04-AMCP-0342

K BASINS INTERIM REMEDIAL ACTION DESIGN CHANGE – K EAST BASIN SLUDGE
CONSOLIDATION CONTAINERS

FH-0400940
CONTRACT NO. DE-AC06-96RL13200

K Basins Interim Remedial Design Change Description
K East Sludge Consolidation

Figure 1 – Location of K East Sludge Containers

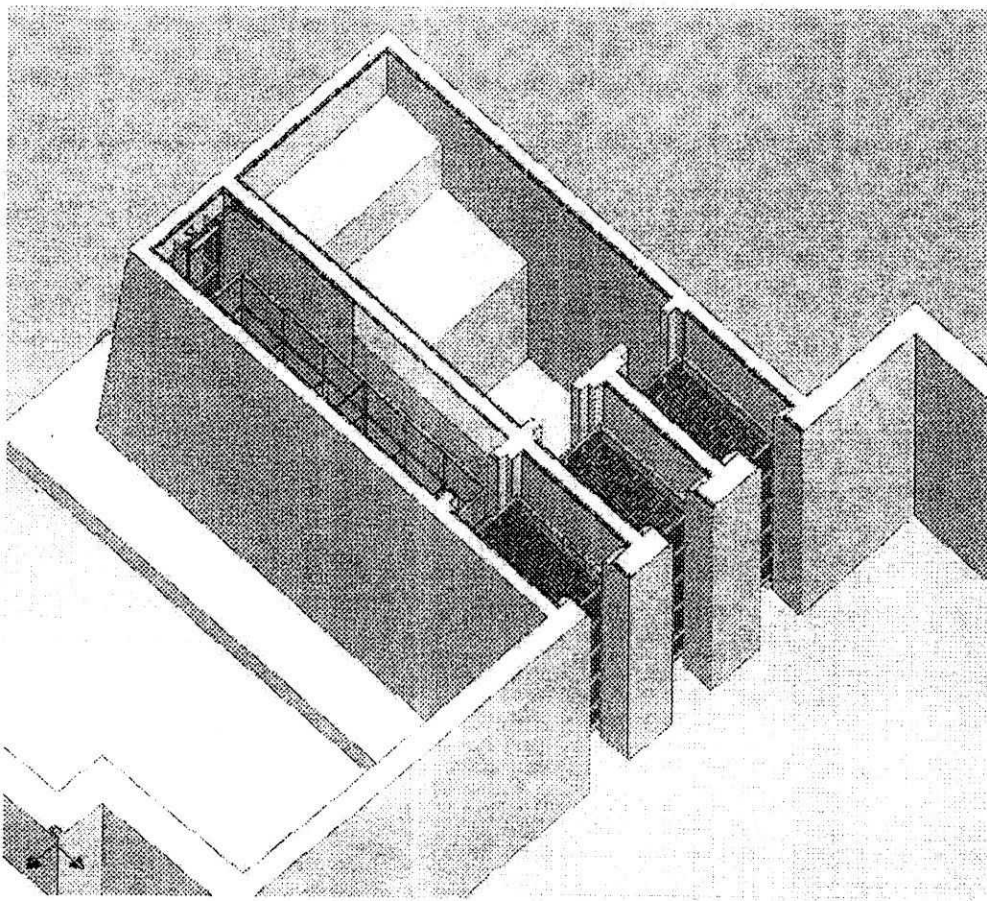
The purpose of the K East Sludge Consolidation System is to consolidate the K East Basin sludge, except for the north loadout pit sludge, into containers located under water in the basin. Consolidating the sludge, material ¼" and smaller, into containers will facilitate inspection of the basin floor for any fuel fragments and their removal. With both fuel and sludge removed off the basin floor, those deactivation and decommissioning (D&D) activities associated with preparing the basin for removal (e.g. grouting) can commence in parallel with removal of the sludge from the basin. The sludge containers will also provide a robust defense in depth improvement in protecting against the release of sludge to the soil and groundwater beneath the basin. The containers will be placed inside the weasel pit, the entrance to the weasel pit, and the two entrances to the tech view pit. (See Figure 1) Sludge from different K East Basin locations, including the main basin floor, tech view pit, weasel pit, dummy elevator pit, will be vacuumed and pumped to the containers located in the pit areas.

Sludge Settling - consists of four open topped containers located in the Tech View Pit entrances, Weasel Pit entrance, and Weasel Pit. Containers are provided with inclined tube settlers. The containers will be open top, rigid, self-supporting, and free-standing. The bottoms of the containers are sloped towards a valve connection on the basin end. Together, the containers have a capacity of approximately 51 m^3 for sludge containment. Each container has inclined-tube settlers installed in its top section to improve particle settling. Each container is equipped with a level detector which will indicate when the sludge in the container is at the designed full level. The clear water overflow will be returned to the basin over the top of the open containers. This overflow will have a turbidity meter to gage the clarity of the water returning to the basin.

Two basic sludge container designs are necessary; one for the weasel pit and one for the entrances to the weasel pit and tech view pits. The design and functional requirements for the sludge containers are as follows:
